Access Compliance Report

Public Rights-of-Way

Intersection ID: 23470	Main Street: BRANDON_FOREST_DR	Cross Street: STRADBROOK_DR	Location:	N
ADA ID: 9FB0E9F0B195	Ramp Type: Directional1	Initial Pass/Fail: Fail	Overall Compliance: No	Severity Score: 12.5
Codes/Mitigation Info/Possible Solution		Field Measurements/Component Compliance

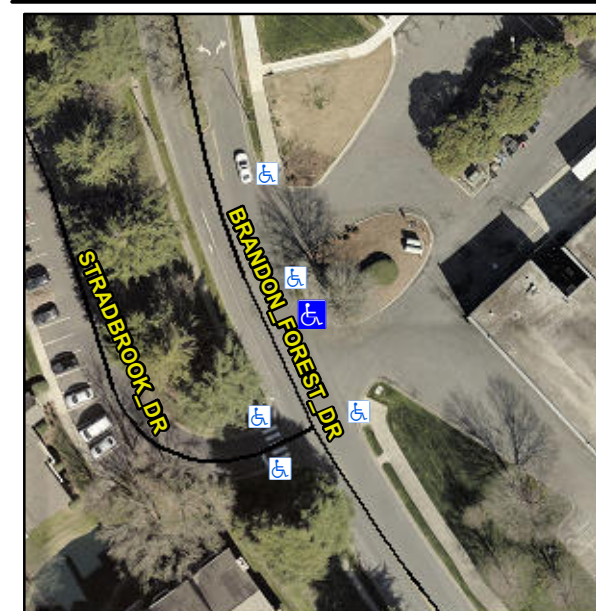
R304.5.3

Compliance	Description	Data	Compliance	Description	Data
N/A	Ramp Length (in)	99.0	N/A	Grade Break?	N/A
Yes	Ramp Width (in)	97.0	N/A	Grade Break Slope (%)	0.0
Yes	Ramp Slope (%)	0.2	N/A	Grade Break XSlope (%)	0.0
No	Ramp XSlope (%)	5.1			
N/A	Flare Type LT	N/A	N/A	Flare Type RT	N/A
N/A	Flare Slope LT (%)	N/A	N/A	Flare Slope RT (%)	0.0
N/A	Flare Traversable LT?	N/A	N/A	Flare Traversable RT?	N/A
N/A	Landing Length (in)	0.0	N/A	DWS Provided?	N/A
N/A	Landing Width (in)	0.0	N/A	DWS Contrast?	N/A
N/A	Landing Slope (%)	0.0	N/A	DWS Length (in)	N/A
N/A	Landing X Slope (%)	0.0	N/A	DWS Full Width?	N/A
N/A	Landing Curb? (Y/N)	N/A	N/A	DWS Offset LT (in)	N/A
N/A	Shared Landing?	N/A	N/A	DWS Offset RT (in)	N/A
N/A	Gutter Ponding?	0.0	N/A	Gutter Slope (%)	N/A
N/A	Gutter Lip Ht (in)	0.0	N/A	Gutter X Slope (%)	N/A
N/A	Painted X Walk1?	No		Road Slope (%)	5.5
	X Walk 1 Direction	To SE		Road X Slope (%)	1.1
	X Walk 1 Width (in)	N/A		Clear Space?	N/A

Remove & Replace Entire Ramp.
